Project No. 21482114

**RESPONSE TO GEOTECHNICAL PEER REVIEW COMMENTS FROM GEMTEC
PROPOSED RESIDENTIAL DEVELOPMENT
3930 AND 3960 RIVERSIDE DRIVE, OTTAWA, ONTARIO**

A geotechnical peer review was completed by GEMTEC on behalf of the City of Ottawa and the relevant comments were provided in GEMTEC Letter no. 100008.025 – Rev0, dated Dec 7, 2023. The comments are noted below with response from WSP.

PROJECT NO.	CONTROL	REV.	FIGURE
21482114	0005	0	1

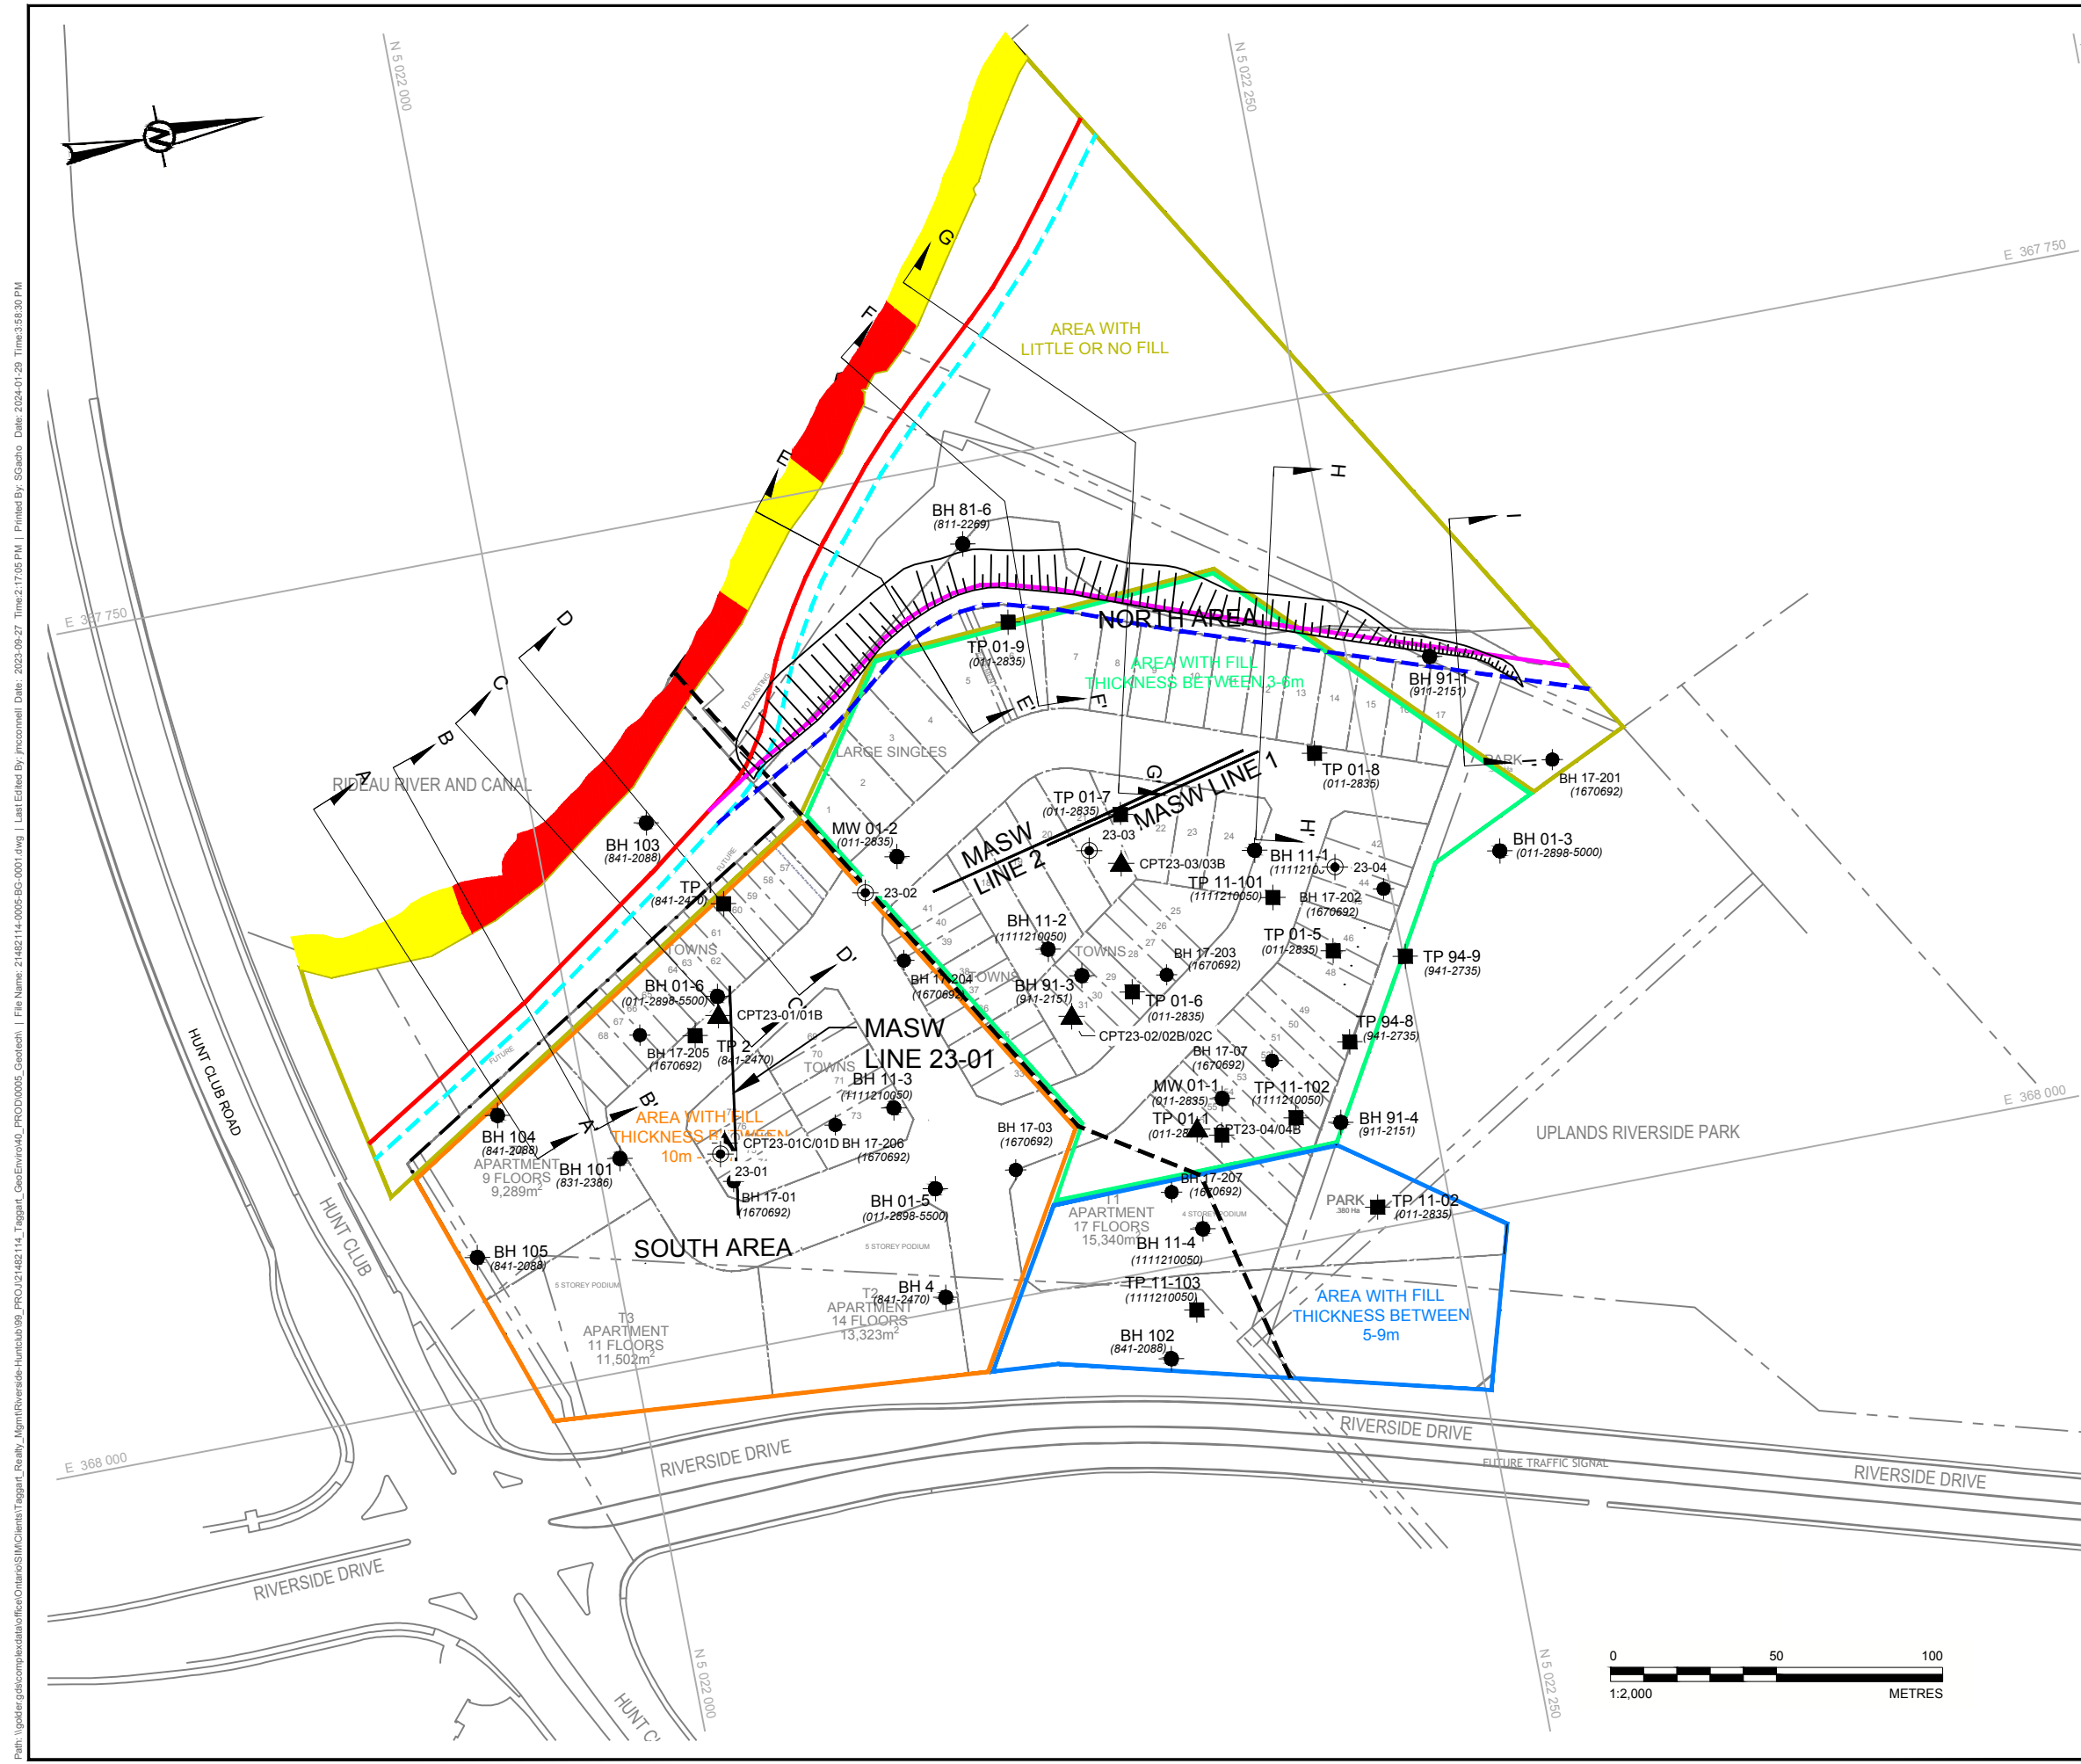
- 1) "The site plan in the report (i.e., Figure 1) indicates the locations for the following test pits or borehole but the records do not seem to be included in the report.
 - Testpits 1 to 17 (Project No. 011-2898);
 - Testpits 94-15 and 94-18 (Project No. 941-2135);
 - Testpits ST-1A, ST-1B, ST-1C, ST-2A, ST-2C (Project No. 1111210050); and,
 - Boreholes 3, 5, and 6 (Project No. 841-2470)"

- 2) "In addition, the following was also noted with respect to the testhole records and site plan:
 - TP 11-102 (011-2835) and TP 11-02 (1111210050) seem to be mis-labelled; and,
 - There appears to be an unlabelled testpit marker in the area between BH 91-3, CPT23-02/02B/02C, and 17-203 (approximately in the middle of the site)."

- 3) "The MASW testing was carried out within the North Area, where the fill thicknesses are significantly less than in the South Area (i.e., 6 to 7 metres at the MASW lines versus up to 20 m thickness in the South Area). Due to the significant difference in stratigraphy, it is not clear that the obtained shear wave velocity values are representative within the South Area or that the interpreted Site Class D based on those values is also applicable for the South Area. "

Response - *The above noted records could not be located in our archives and have therefore not been included in the report. The locations of these boreholes and test pits have also been removed from the site plan for clarity.*

Response - *The above has been corrected on the site plan.*

Response – *Additional MASW testing within the South Area was carried out by Conetec on 2 March 2023 (See Appendix G of the WSP report). The results are consistent with a Site Class D. This MASW line has now been added to the Site Plan (Figure 1).*

Title: Cross Section A-A
File Name: 21482114_Section A-A_1m higher_10_MG.gsz
Name: Seismic Undrained
Method: Morgenstern-Price
Horz Seismic Coef.: 0.15

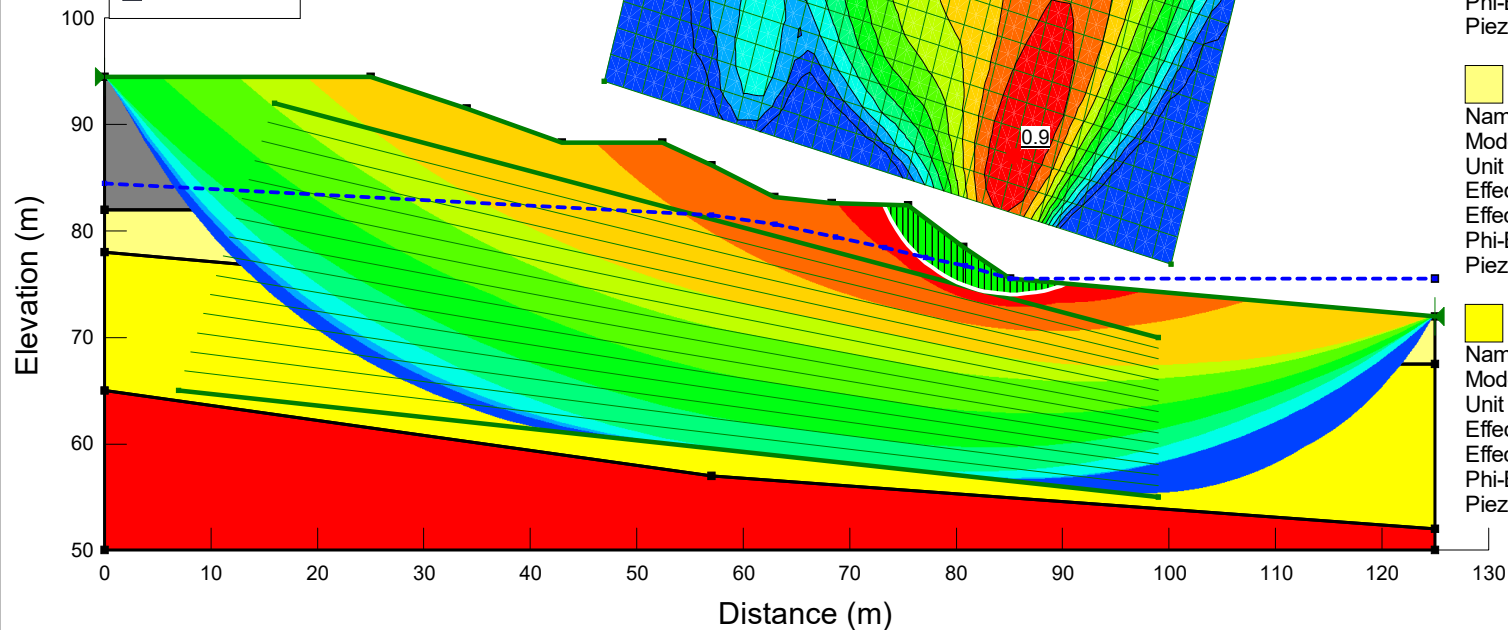
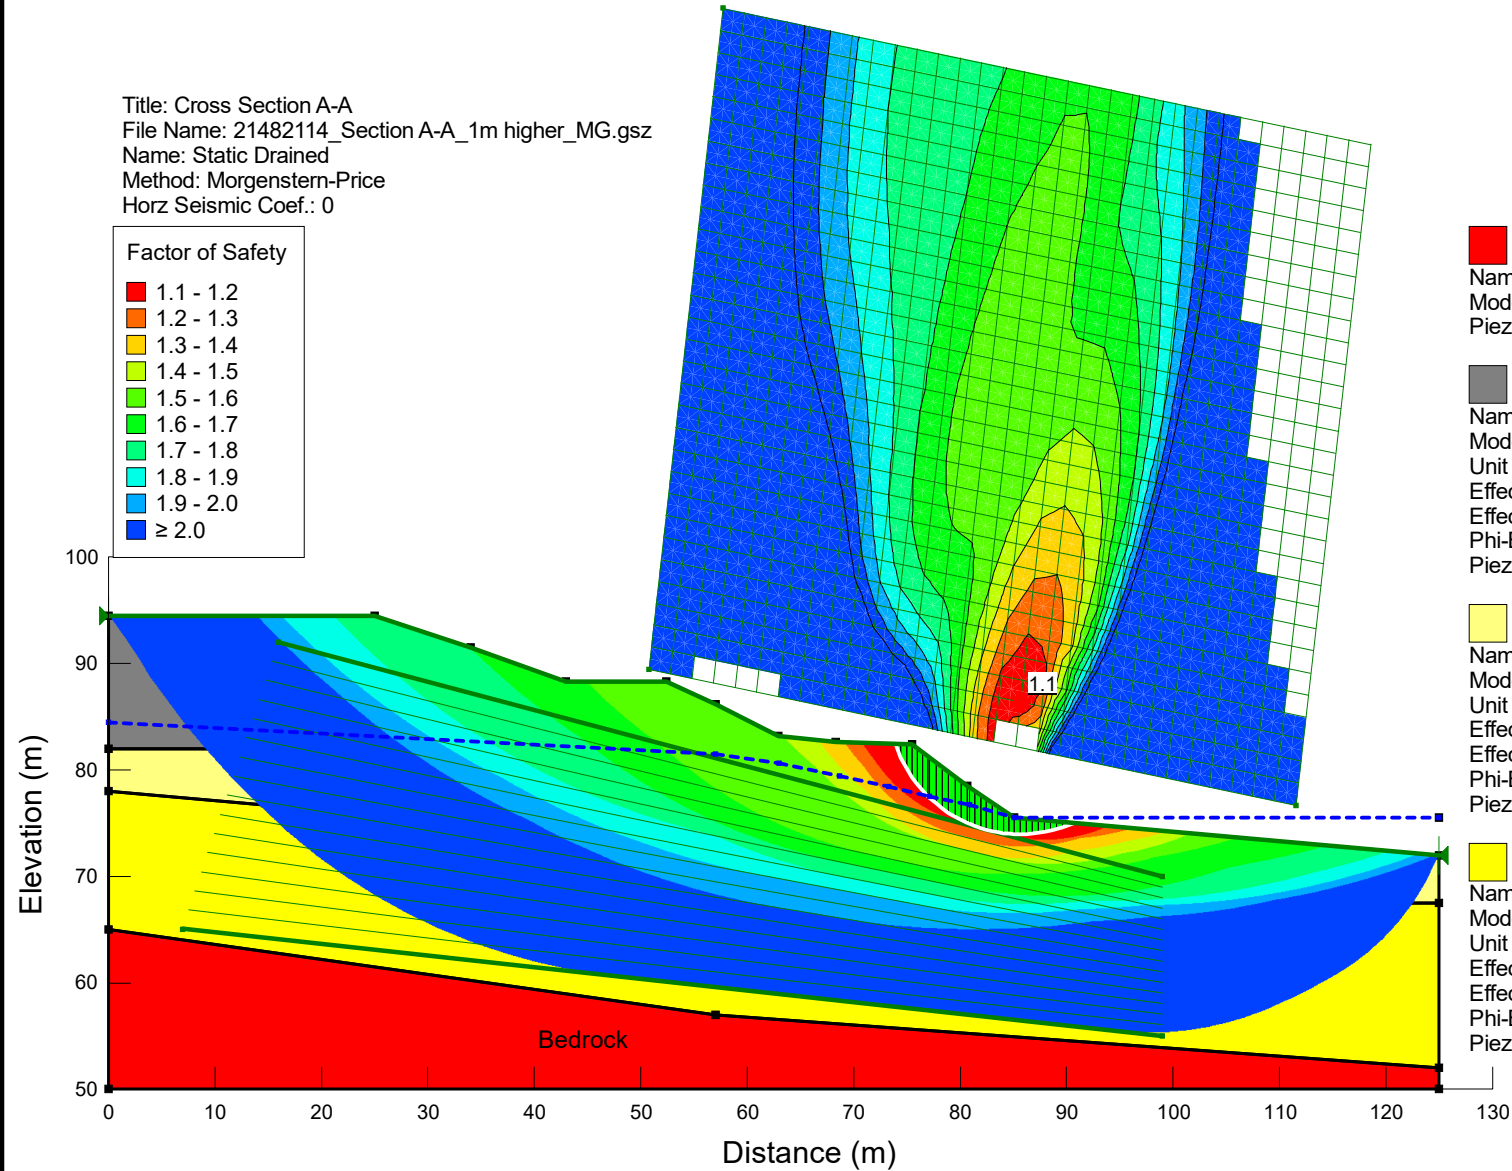
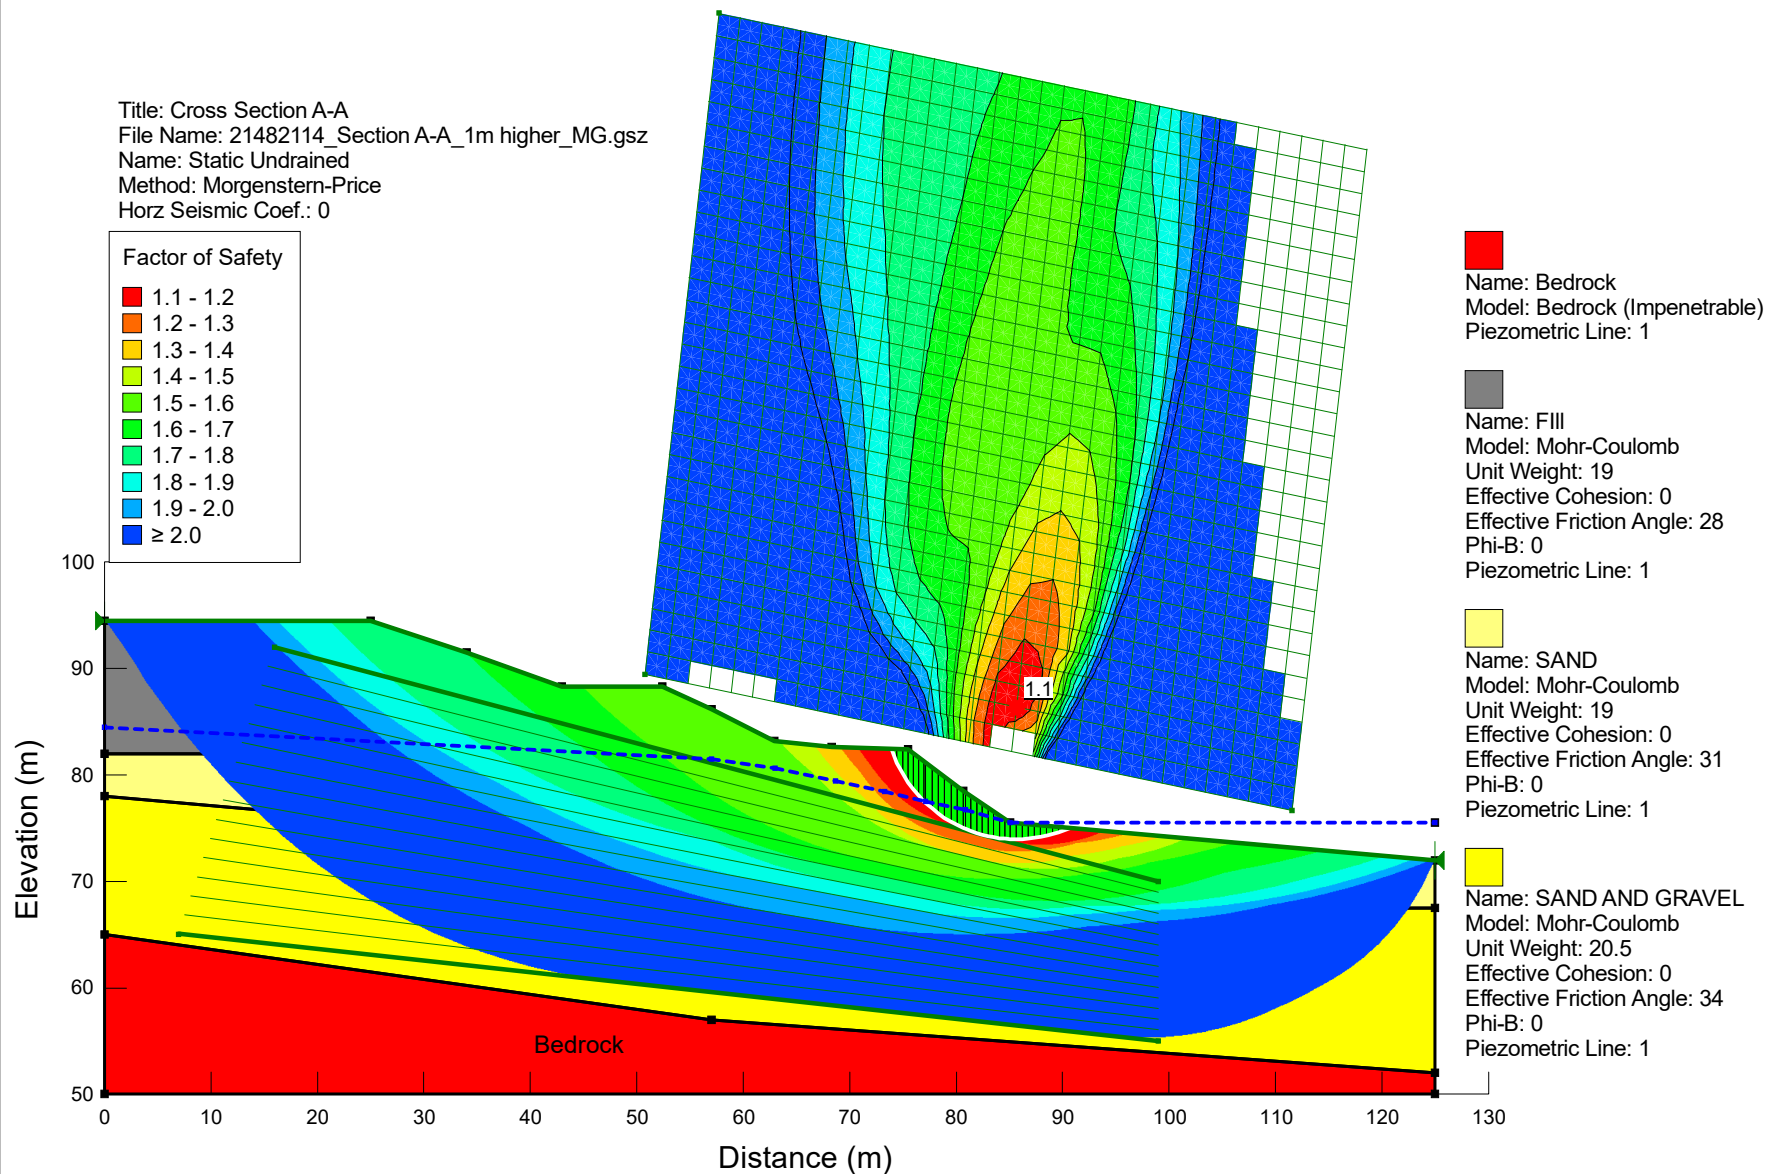
- 4) “The following comments are provided for the slope stability analysis carried out for Sections A-A', B-B', C-C', and D-D'. The safety map for the static and seismic analyses for the values of less than 1.5 and 1.1 respectively, extends past the upper edge of the point grid (for the slip circle centre), which may indicate there are slip circles with those factors of safety or less that extend horizontally farther than currently shown. This could potentially result in an increased stable slope allowance, and it is suggested that the model geometry be revised (by extending the point grid) to check the limits.”

- 5) “The groundwater level assumed in the static analyses for the South Area is at the base of the existing fill (i.e., at elevations of about 82 to 83 m) and is indicated to be based on the water levels measured in the various monitoring wells at the site. This would be Case 3 as outlined in the slope stability guidelines and may not be a realistic assumption. The fill materials above the native sands are not uniform in composition and contain cohesive layers and materials with high silt and clay contents that will tend to retain water and therefore it may not be reasonably conservative to assume the fill materials are fully drained as assumed in the slope stability analyses. The water levels summary in Section 4.1 of the report notes that: “In the South Area, the groundwater level was generally found to be between 12 to 16 m depth (i.e., between elevations of about 75 to 83 m), but as shallow as about 6 m (i.e., elevation of about 88 m).”

Response – *The models for the sections identified above were revised (by extending the point grid), no differences have been observed in the stable slope allowance.*

Response – *While the water level in the south area was recorded to be between elevations of 75.1 and 87.6 m (in monitoring wells as well as from CPT Dissipation testing), it was generally found to be below elevation of 79 m. Only one single borehole location had a higher water level of 87.6. We therefore feel that the original assumptions regarding groundwater level are reasonable assumptions for the overall groundwater depth in the area of interest. Nonetheless, as a precautionary measure and an additional check, the slope stability models for these four sections were revised to take into account for the possibility of a higher groundwater level in South Area by adjusting the piezometric line in the analysis upward in the east side of the site (where the single high level was recorded). This adjustment results in a very minor change to the slope stability (well within the margin of error of the data and assumptions which go into the analysis). The change is of sufficiently small magnitude as to make no meaningful difference to recommended stable slope allowance, and therefore we feel that the originally recommended setbacks may be maintained. The results of the revised slope stability analysis are attached to this memorandum.*
